SAFETY NOTICE

Issued by Angus Pinkerton Chairman of the Flying & Safety Committee 1st April 2019.

Safety Notice Quick-Out Carabiner

The picture on the right shows a Quick-Out carabiner with a faulty mounted release button:

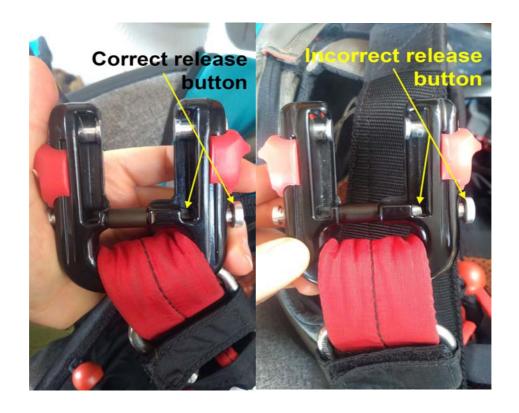
When setting up the production of the Quick-Out release buttons in January 2015, about 20 release buttons of one side were produced incorrectly. Some of these release buttons were accidentally mounted and at least one such faulty Quick-Out carabiner was put into circulation. The error eliminates one of the 4 security levels: To open the carabiner, it is sufficient to press only the correct

release button instead of pressing both release buttons simultaneously.

At the final inspection, every single Quick-Out carabiner undergoes a load test of 2,000 DaN. However, the error was not noticeable, since the stress test is also passed with only one release button intact.

We urge all Quick-Out users to check the carabiners before the next use.

We have introduced additional testing procedures for the final inspection of the Quick-Out carabiners to reliably prevent such errors in the future.
